Subject: Willatook Wind Farm – Proposed amendments to the assessed turbine layout

1.1 Purpose of this memo

This memo considers the implications of the proposed changes shown in *WTG_WIL_V172-7_2_v121.shp* on the LVIA findings and the December 2025 review.

Figure 1 Turbine Layout comparison

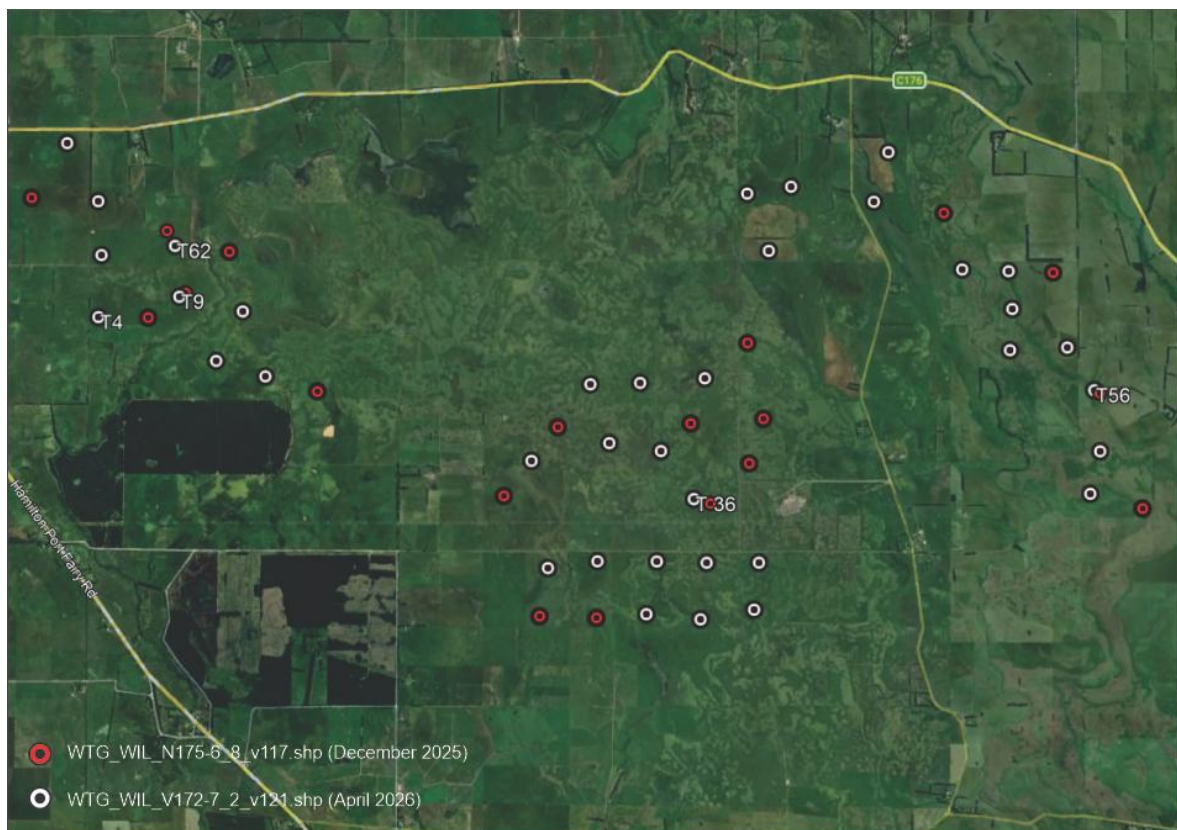
The amendments shown in *WTG_WIL_V172-7_2_v121.shp* are limited to minor positional adjustments to a small number of turbines, summarised below:

- T4 – approximately 10 m to the north-east
- T9 – approximately 85 m to the south-west
- T36 – approximately 200 m to the north-west
- T56 – approximately 75 m to the north-west
- T62 – approximately 205 m to the south-east

There is no change to:

- the overall scale or extent of the wind farm;
- the spatial distribution of turbines; or
- The composition of the layout when read in the landscape and views.
